SUBJECT: Army Installation Restoration Program, Seneca Army Depot, NY, Remedial Investigation/Feasibility Study at Open Burning Grounds, Final Scope of Work (SOW) for Work Plan Preparation, Project No. SEAD-0001

Response to SSSSE-HE Comments

REMEDIAL INVESTIGATIONS AND FEASIBILITY STUDIES
AT THE OPEN BURNING GROUNDS
PHASE I - PREPARATION OF WORK PLANS
SENECA ARMY DEPOT, ROMULUS, NEW YORK

Figure 2.1. Conceptual model for the Seneca Burning Pits/Landfill

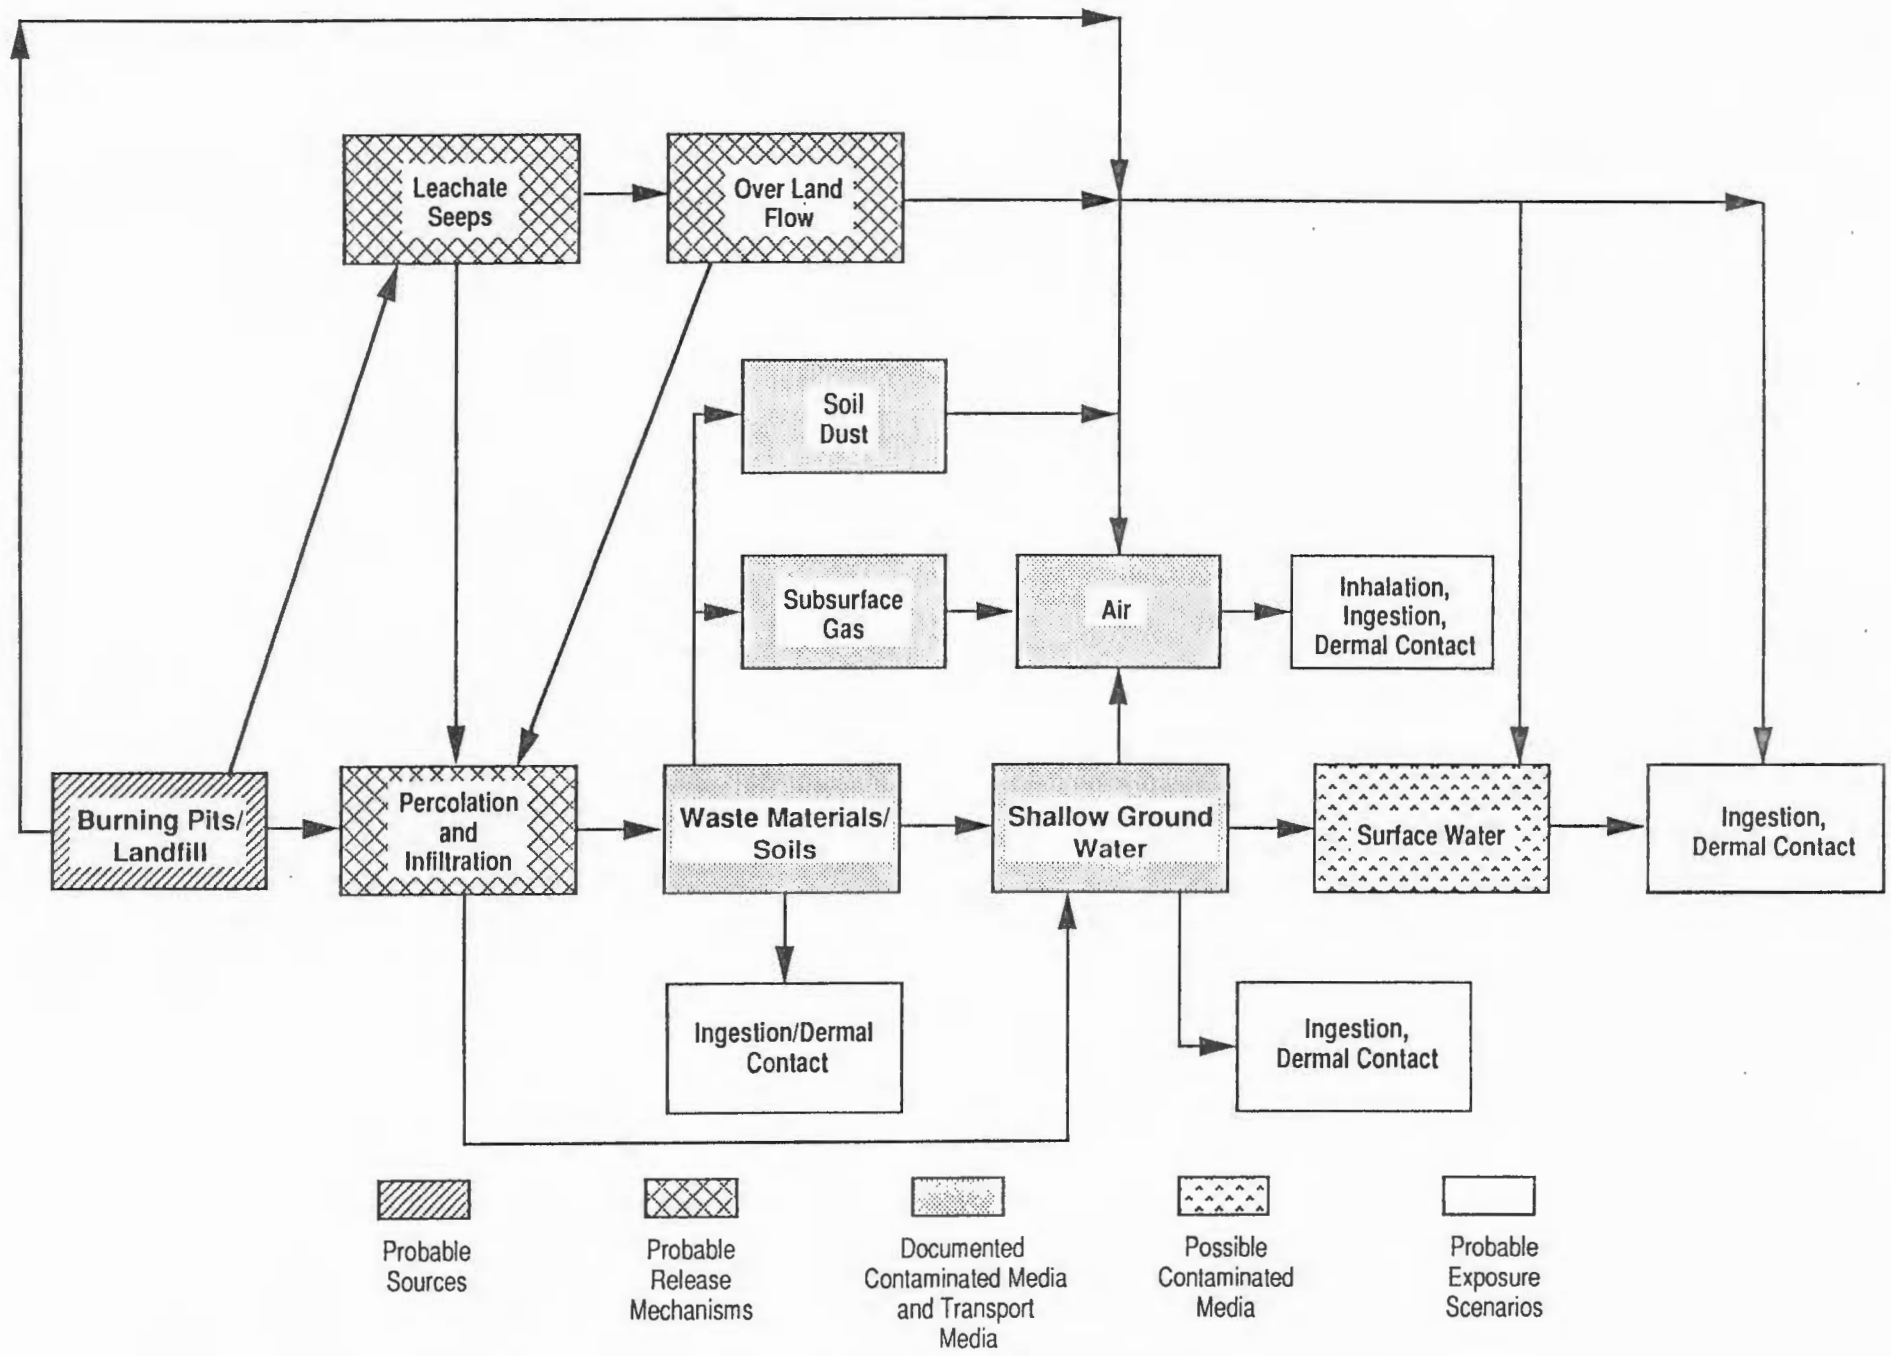
To illustrate the points of the above discussion, EPA has developed a conceptual site model for the SEAD landfill which is presented as Figure 2.1. The model presents the suspected source(s), potential release mechanisms and migration pathways, and exposure routes. According to this illustration, release mechanisms include percolation/infiltration, leachate seeps, and overland runoff. EPA notes that the potential for surface water runoff from the landfill has not been evaluated in the SI, and may in fact pose a more immediate migration pathway than that of ground water transport. It is likely that surface runoff (and perhaps ground water seeps) are impacting the wetland areas to the north, and the surface water bodies to the west of the SEAD property. EPA cannot support the position of the Army contractor to ignore these potential migration pathways due to a lack of understanding of surface runoff conditions. EPA strongly recommends that measures to control these potential release occurrences be incorporated into any interim remedial measure considered for implementation.
